**MEMPHIS AND SHELBY COUNTY OFFICE OF PLANNING AND DEVELOPMENT
STAFF REPORT (Revised) 15**

CASE NUMBER: P.D. 08-314 CC L.U.C.B. MEETING: August 14, 2008

DEVELOPMENT NAME: Gray's Creek Planned Development, 4th Amendment

REQUEST: Amend the current Areas C and D to add a maximum of 336
apartment units in 42 buildings

Concept Plan

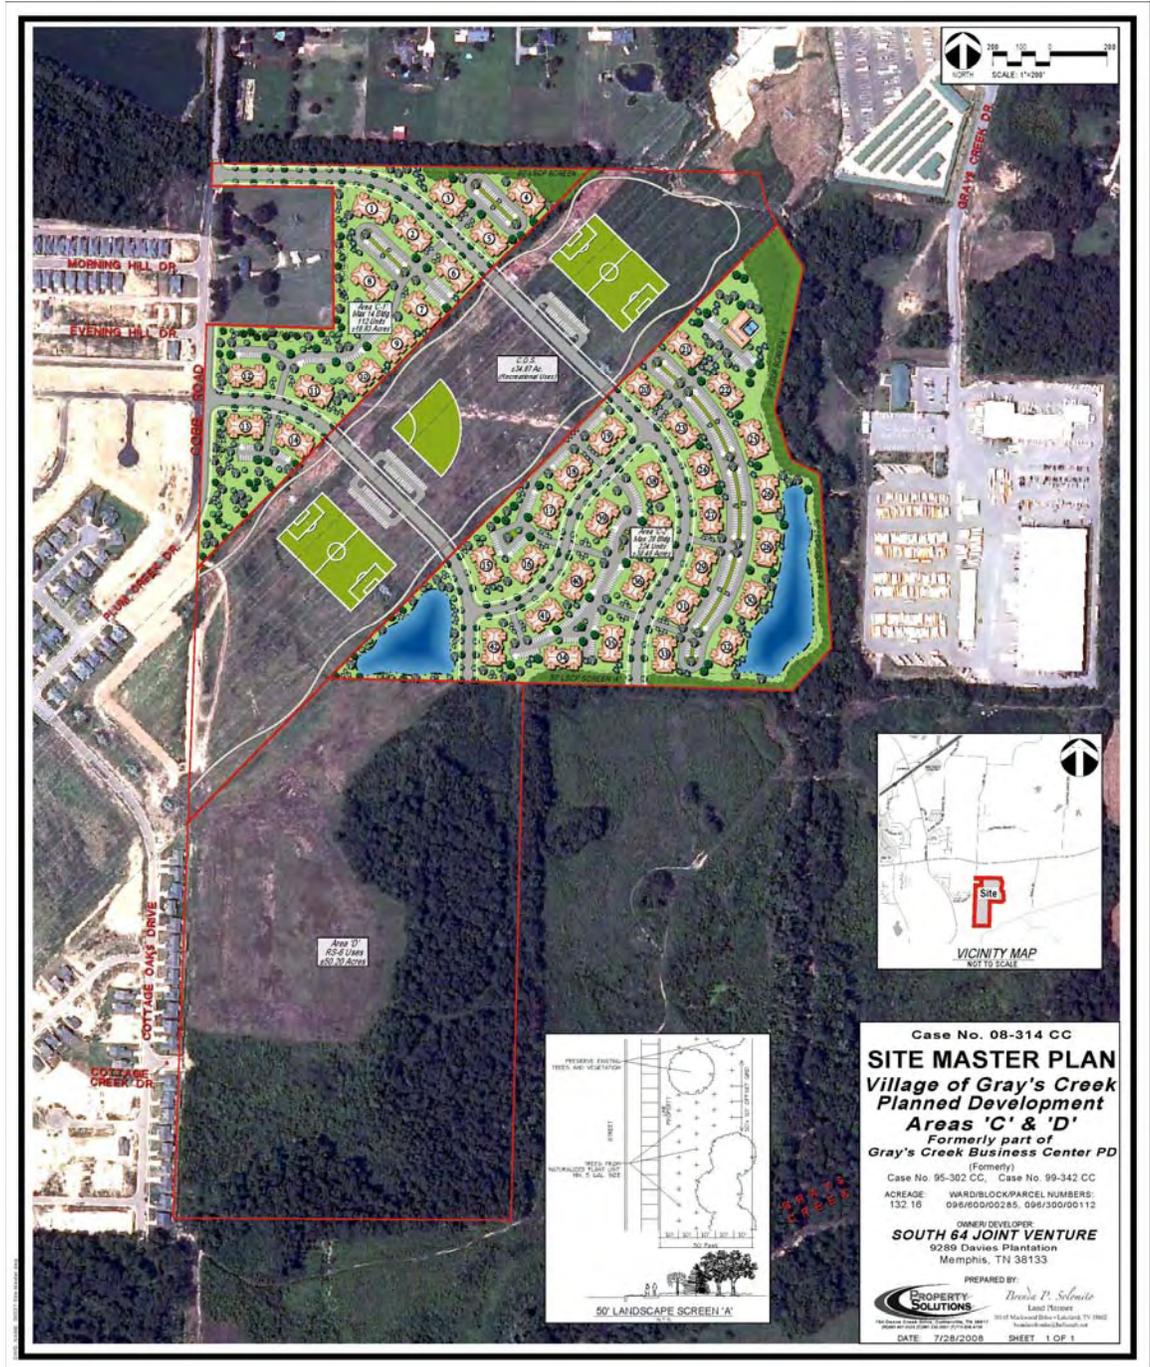
5. The applicant has redesigned the site plan to orient the buildings to the public streets and re-locate the parking areas behind the residential structures. The applicant has also provided two examples as typical building types that have more of a single family character. The staff is amenable to a mixture of the two building types illustrated here. The conditions will further reflect that the buildings should be varied in style and materials so that there is not a continuous row of buildings that are exactly alike which is the case of a typical apartment project.

The applicant has redesigned the site plan to orient the buildings to the public streets and re-locate the parking areas behind the residential structures. The applicant has also provided two examples as typical building types that have more of a single family character. The staff is amenable to a mixture of the two building types illustrated here. The conditions will further reflect that the buildings should be varied in style and materials so that there is not a continuous row of buildings that are exactly alike which is the case of a typical apartment project.

5. The east/west cross street in Area C, designated as Cottage Creek Drive, is shown as a 60 foot right-of-way, which is not consistent with the currently constructed stub in Franklin Farms PD, Phase 4, (a 31 foot alternate design street). Therefore, Cottage Creek shall be a 31 foot alternative design street up to the intersection of Old Well Terrace extended.
6. The extension of Old Well Terrace at Cobb Road (shown as a 50 foot right of way) shall be dedicated and improved as a minor collector street with 60 feet of right of way and 40 feet of pavement. The attendant connections (east/west) into the Roland Estates PD, shall be dedicated and improved as major local streets (52/36). If a boulevard cross section is desirable, then the developer shall provide additional right-
